Subject: **SLR Campus Modernization**  
**New Modular Building**  
3535 Hacienda Dr,  
Oceanside, CA 92054

**OUSD Bid No.: 2021-21-73B**

**Project Number: 809-705**

**ADDENDUM NO. 2**

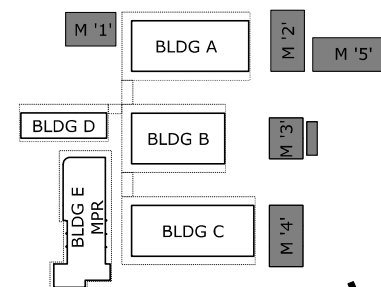
**RFI 12.B: Request individual floor plans for each building. To include casework elevations**

**RFI 30: Please provide a floor plan for the restroom so we can see how it is to be divided – for example boys/girls/staff, and so that we may confirm whether the number of water closets requested will fit and meet ADA requirements, and so that we can determine lavatories and urinals needed.**

**RFI 38: Can you please provide enlarge floor plans for each building.**

**RFI 12.B Answer: We will be referring to the selected Contractor to create and provide Plans. Sheet A-0.7 attachment ADD2-03 has been included for reference.**

**RFI 30 Answer: Sheet A-0.7 attachment ADD2-03 has been included for reference.**

**RFI 38 Answer: We will be referring to the selected Contractor to create and provide Plans. Sheet A-0.7 has been included for reference attachment ADD2-03**
